UNITED STATES PATENT AND TRADEMARK OFFICE

APPLICATION NO.	FILING DATE	FIRST NAMED INVENTOR	ATTORNEY DOCKET NO.	CONFIRMATION NO.
10/728,349	12/04/2003	Philip J. Ellerbrock	038190/270534	8600

Office Action Summary

DETAILED ACTION

The waveform for a Manchester encoded bit stream carrying the sequence of bits 110100.

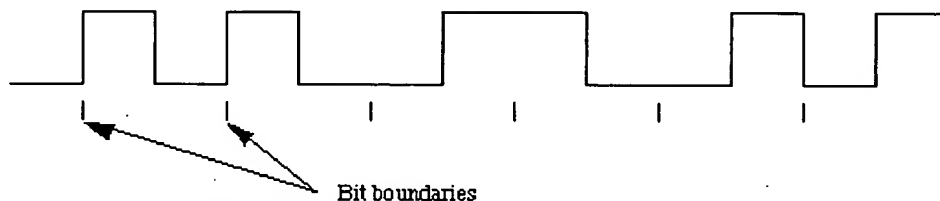
The following diagram shows a typical Manchester encoded signal with the corresponding binary representation of the data (1,1,0,1,0,0) being sent.

In the Manchester encoding shown, a logic 0 is indicated by a 0 to 1 transition at the center of the bit and a logic 1 is indicated by a 1 to 0 transition at the center of the bit.

Note that signal transitions do not always occur at the 'bit boundaries' (the division between one bit and another), but that there is always a transition at the center of each bit. A Manchester encoded signal contains frequent level transitions which allow the receiver to extract the clock signal and determine the timing. See also "Manchester Encoding," cited below as evidence of well-known prior art. Further evidence can be found in Hanna et al., Fig. 2, and description thereof, column 1, lines 22-23; column 1 line 35 to column 2, line 13. The receiver then uses the extracted or recovered clock or bit frequency to communicate back with the transmitter or controller.

It would have been obvious to one of ordinary skill in the art at the time the invention was made to employ Manchester encoding instead of NZR encoding in the communication system of Karolys, since the Examiner takes Official Notice that Manchester encoding, as explained above, is old and well-known in the art (as an alternative to NZR encoding); and using Manchester encoding instead of NZR encoding in Karolys only involves ordinary skill in the art for the purpose of providing a "number of advantages" over the NZR encoding (see "Manchester Encoding," cited below). Once the Manchester encoding is employed, it is clear that the clock or bit frequency embedded in the first message independent of a synchronous clock signal from the bus controller (BCM 28 connected to Host 14) is used by the network device interface (TBIM 26) to transmit a second message to the bus controller (BCM 28 connected to Host 14) in response to the first message at the embedded predetermined bit rate. It would also have been obvious to one of ordinary skill in the art at the time the invention was made to alter/adjust/change the bit rate during data transmission for the purpose of changing
